DEVELOPMENT REVIEW COMMITTEE

CASE COMMENT REPORT

CASE NO. UDP-S24035

CASE:	UDP-S24035
MEETING DATE:	May 28, 2024
REQUEST:	Site Plan Level III Review: Conditional Use for Increased Building Height and Yard Modifications for a 38-Unit Multifamily Residential Development
APPLICANT:	A1A N Ocean Blvd., LLC.
AGENT:	Stephanie Toothaker, Esq.
PROJECT NAME:	The Amalfi
PROPERTY ADDRESS:	2317 – 2237 North Ocean Boulevard
ZONING DISTRICT:	Residential Multifamily High Rise/High Density (RMH-60)
LAND USE:	High Residential
COMMISSION DISTRICT:	2 – Steven Glassman
NEIGHBORHOOD ASSOCIATION:	Central Beach Alliance
CASE PLANNER:	Karlanne Devonish

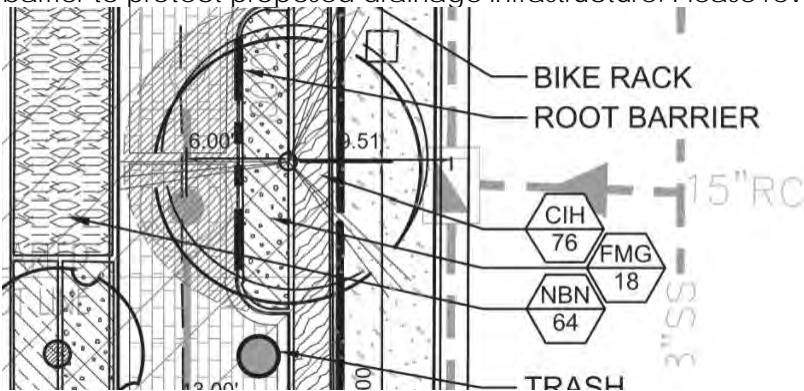
3. It has been policy to allow for required ROW sidewalk area to count towards required landscaping area when placed on-site within property lines as per the City's request, such as illustrated along SR A1A on Sheet X4 Open Space/Pervious Areas Exhibit. However, this policy shall not extend to all paved areas on-site, even when connected to the required ROW sidewalk area, such as the plaza space shown below. The area may count towards open space requirements. Please revise drawings and calculations accordingly.
